**IN THE DRAWINGS:**

## REMARKS

This is intended as a full and complete response to the Office Action dated March 31, 2006, having a shortened statutory period for response set to expire on June 30, 2006. Please reconsider the claims pending in the application for reasons discussed below.

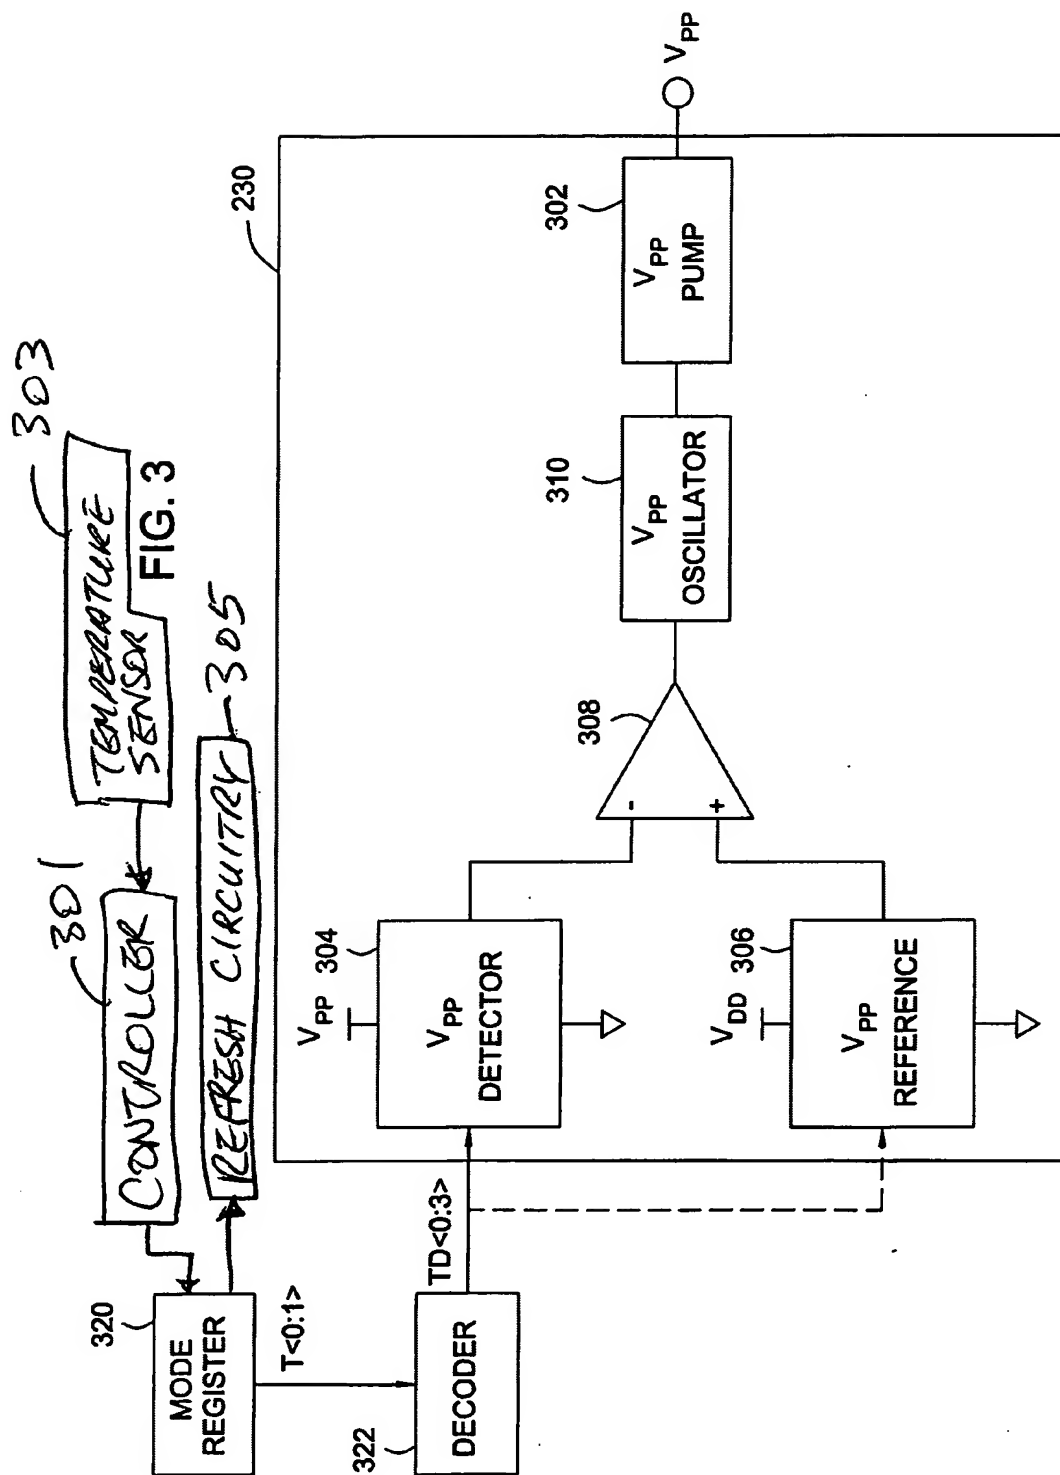
The drawings are objected to under 37 CFR 1.83(a). In Section 1 of the Office Action, the Examiner asserts that Fig. 3 fails to show the external temperature sensor which provides the temperature information. Appropriate amendment to Fig. 3 has been made, as described above. Withdrawal of the objection is respectfully requested.

In Section 2 of the Office Action, The Examiner also requests that the refresh circuitry as recited in claims 3, 17 and 23, the feature as recited in claim 18, an external device as recited in claim 16, and the peripheral circuitry as recited in claim 25 must be shown or the feature(s) canceled from the claim(s). Revised Fig. 3, submitted herewith, shows a temperature sensor, as requested in Section 1 of the subject Office Action. Moreover, Fig. 3 shows refresh circuitry, as requested in Section 2 of the subject Office Action. Applicants submit that Figure 3 also provides support for the feature of claim 18. The controller shown in Fig. 3 may be an external device, as recited in claim 16. The refresh circuitry shown in Fig. 3 represents a peripheral circuitry, as recited in claim 25.

In Section 3 of the Office Action, the Examiner also objects to the drawings as failing to comply with 37 CFR 1.84(p) (5) because they do not include the reference sign(s) 304 (line 8, page 9) and 306 (line 9, page 9) mentioned in the description.

With respect to Claim 1, the Examiner states that it is not clear how obtaining temperature can comprise reading one or more bits in a mode register since Fig. 3 of the present invention does not show any temperature sensor associated with mode register 320. Applicants submit that revised Fig. 3, submitted herewith, shows the requested temperature sensor associated with mode register 320. Withdrawal of the rejection is respectfully requested.

With respect to Claims 3, 17 and 23, the Examiner states that it is not clear how the refresh rate of the memory device can be varied since there is no refresh circuitry is shown in the drawings of the present invention. Applicants submit that revised Fig. 3, submitted herewith, shows the requested refresh circuitry. Withdrawal of the rejection is respectfully requested.

The attached sheets of drawings includes changes to Figs. 3 and 4. Fig. 3 has been amended to depict a controller, a temperature sensor and a refresh circuitry. As far as original support for the temperature sensor and the controller is concerned, support can be found in the specification at least, for example, at Para. [0031], lines 1 to 6. With respect to the refresh circuitry, support can be found in the specification at least, for example, at Para. [0031], lines 3 to 7. Previous Fig. 4 has been replaced with new Figs. 4A and 4B. Reference numbers 304 and 306 have been introduced into the new Figs. 4A and 4B as requested by the Examiner.

Accordingly, it is believed that all elements indicated in Sections 1 and 2 of the subject Office Action are shown in the revised Fig. 3. Withdrawal of the objection is respectfully requested.

Revised Figs. 4A and 4B, submitted herewith, contain the reference signs requested by the Examiner. Withdrawal of the objection is respectfully requested.
